Review Response

LAND AT OAKLEY FARM, CHELTENHAM, NEW RESIDENTIAL DEVELOPMENT

Housing Enabling Comments- Oakley Farm, 23/01691/REM.

Oakley Farm – Final Landscape Comments

Bin storage and access

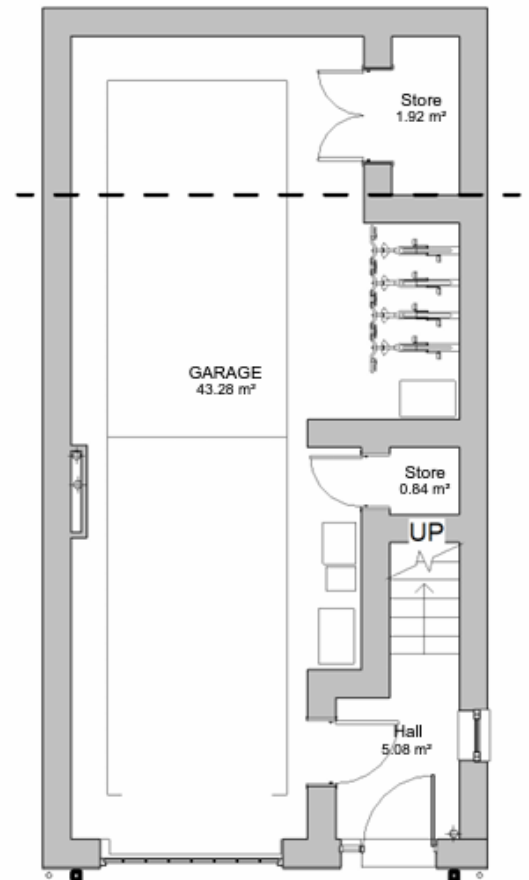
All terraced houses have front bin storage which is certainly a positive feature. We would need to see detailed plans of the construction, application of materials and sizes, to ensure that sufficient space is provided for the required bins. It might also be sensible to consider if additional storage space could be provided for EV charging cables.

1101 Front Elevation
1 : 100

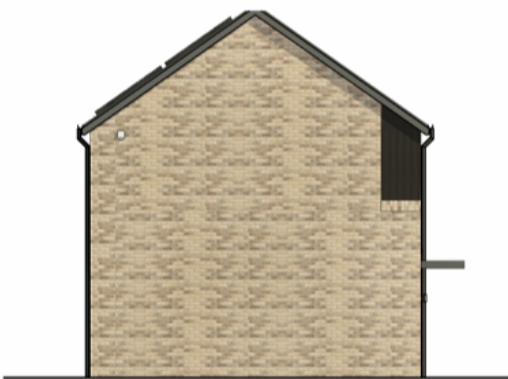
Where dark cladding is applied to the upper levels of properties, it is generally better to continue wrapping the cladding around the front and the sides (as with the Spruce Retaining GF, applied to plots 26, 28, 89 and 90, or the Chestnut No Gable type). This avoids awkward joins in prominent locations and the effect of the cladding just stopping partly around the corner, which is not a positive way to finish the effect. For example, for the mews plots including no.27 (Buckthorn), the sides should be clad, finishing into the corners. The sides, although partly concealed by the first floor amenity spaces, will still be visible as people move along the streets.

The different effects can be clearly seen within the Plot 25 (Buckthorn side balcony) elevation sheet (see below), with a more positive effect seen in the examples where cladding is applied across the whole facade.
